PLANS *EXISTING - PROPOSED*

GROUND FLOOR PROPOSED | AMENDMENTS IN GREEN | 4TH MARCH 2024

AMENDMENTS PROPOSED BY:
KARL EVANS
19 HEATHER COURT
QUAKERS YARD
TREHARRIS
CF46 5RP

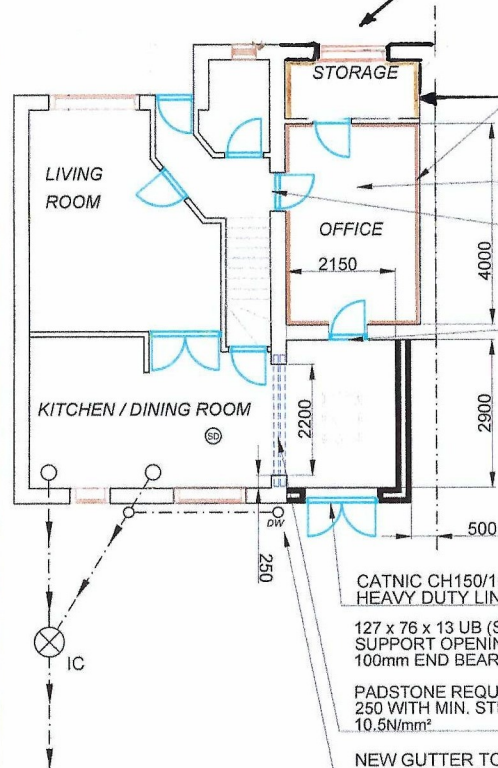
NOTE:
PARTITION TO BE ADDED TO GARAGE TO MAKE STORAGE / OFFICE SPACE.
ACCESS TO THE OFFICE VIA EXISTING HALLWAY AND THE REAR OF THE EXTENSION
TO BE ADDED.

SIDE WALL OF KITCHEN TO BE OPENED UP TO MERGE WITH NEW SIDE EXTENSION.

GARAGE DOOR TO BE REPLACED WITH MATCHING
UPVC WINDOW AND RENDERED BLOCKWORK CAVITY
WALL TO MATCH EXISTING FINISH AND SILL
HEIGHT OF LIVING ROOM WINDOW

GARAGE MASONRY WALLS TO BE LINED WITH
CELOTEX PL4000(65+12.5mm) WITH TAPED
JOINTS ALL AS PER MANUFACTURERS
INSTRUCTIONS TO ACHIEVE MIN. 0.3W/m.sq.K

GARAGE FLOOR TO BE UPGRADED WITH
GA4070 INSULATION, 65mm SCREED AND
20mm INSULATION PERIMETER UPSTANDS
TO ENSURE MIN. U VALUE OF 0.25W/m.sq.K

NEW OPENING TO BE
SUPPORTED WITH
CATNIC CH HEAVY DUTY
LINTEL WITH 150mm END
BEARING

127 x 76 x 13 UB (S275) TO
SUPPORT OPENING (2 OFF)
100mm END BEARING

PADSTONE REQUIRED 100 X
250 WITH MIN. STRENGTH OF
10.5N/mm²

FRONT ELEVATION PROPOSED

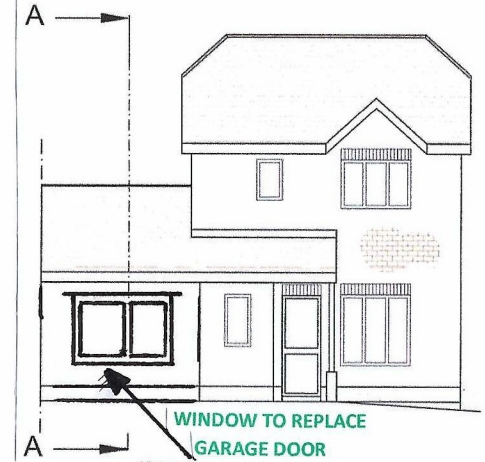
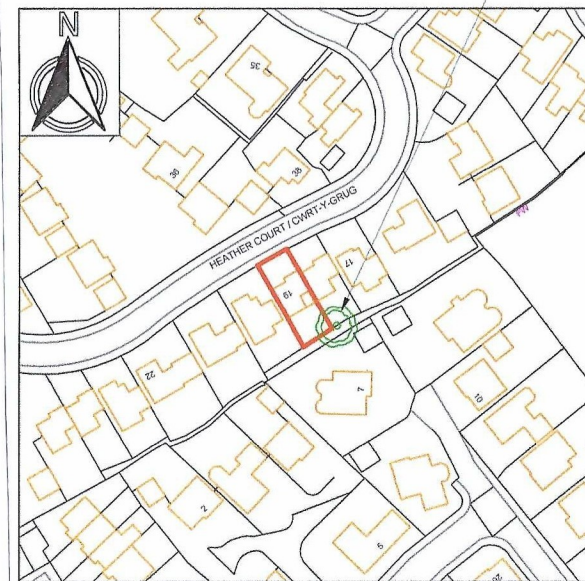
WINDOW TO REPLACE
GARAGE DOOR
